**Consolidated Responses to JRP’s Information Request (IR)  
Packages 12, 12a, 12b, 13, and Clarifications to IRs EIS-12-513,  
EIS-12b-512 and EIS-12b-513 for Deep Geologic Repository Project  
for Low and Intermediate Level Waste**

**July 8, 2014**

Timeframe: <100 years

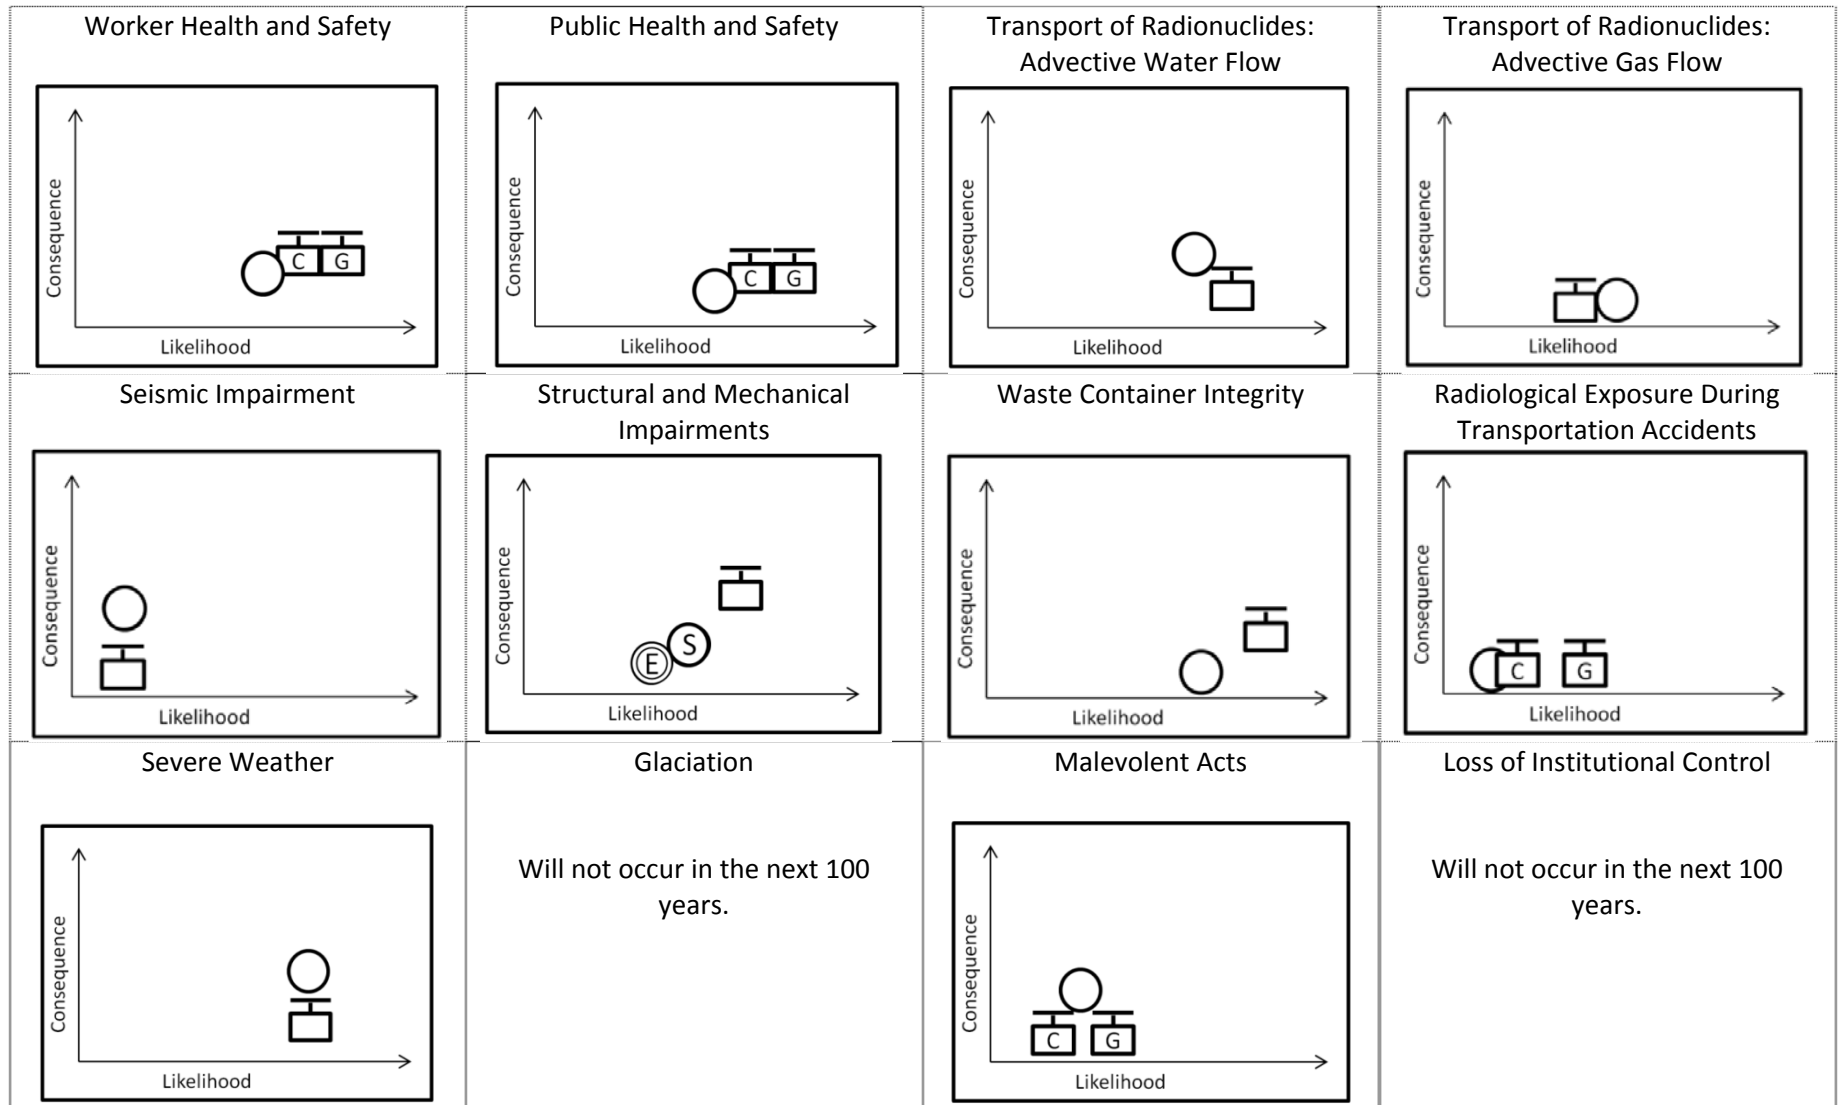
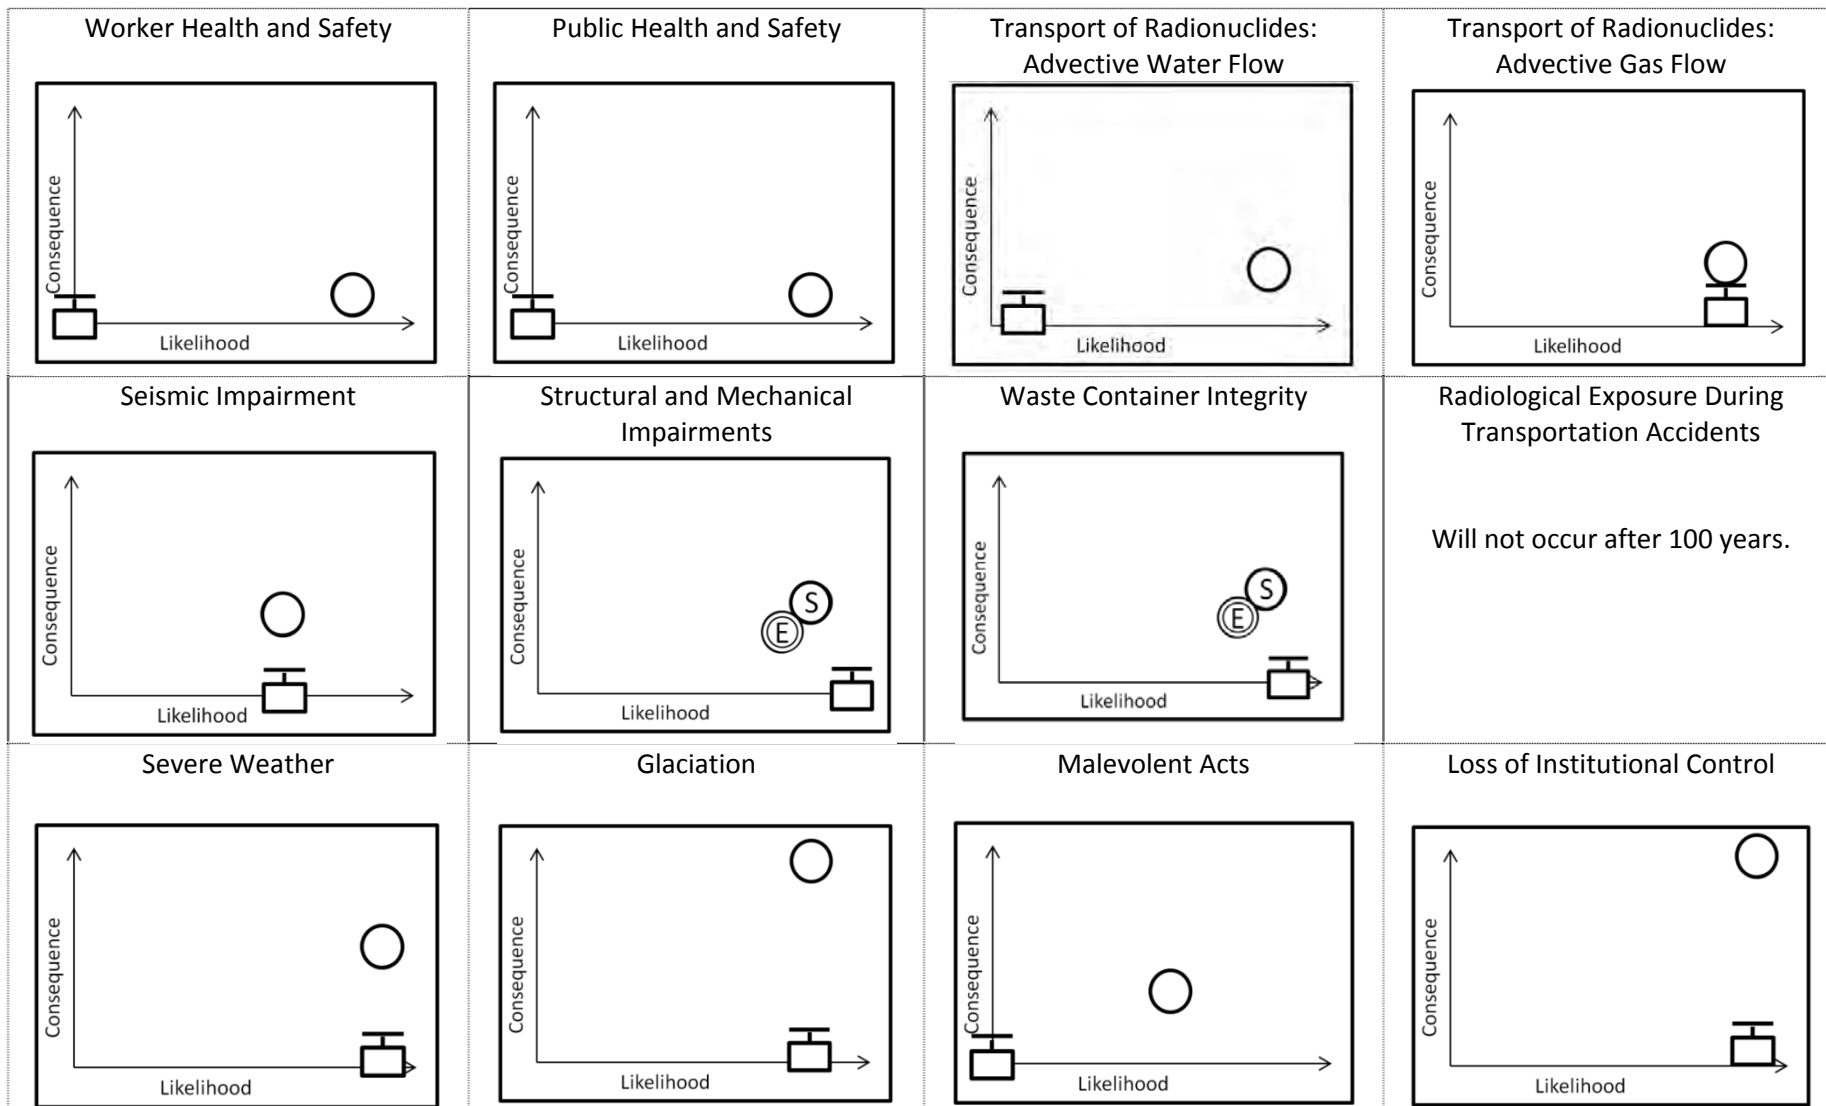
EIS 12b-513 (clarification)	<ul style="list-style-type: none"> <li>Section 7.3, Alternative Means of Carrying out the Project</li> </ul>	<p><b>Clarification Request:</b> <i>A revision of Figure 2 (timeframe &lt;100 years) in the report of the Independent Expert Group in relation to the response to information request EIS 12b-513 (May 30, 2014). Clarification is required regarding what appears to be an inconsistency between Figure 2 and Figure 23 in Appendix II of the same submission. In Figure 2, the likelihood of Malevolent Acts (MA) for the Conceptual DGR in granite bedrock is less than that for the proposed DGR in the Cobourg Formation. This is the reverse of what is shown in Figure 23 in Appendix II.</i></p> <p><b>OPG Response:</b> A revised report by the Independent Expert Group on additional figures and interpretation in support of qualitative risk</p>
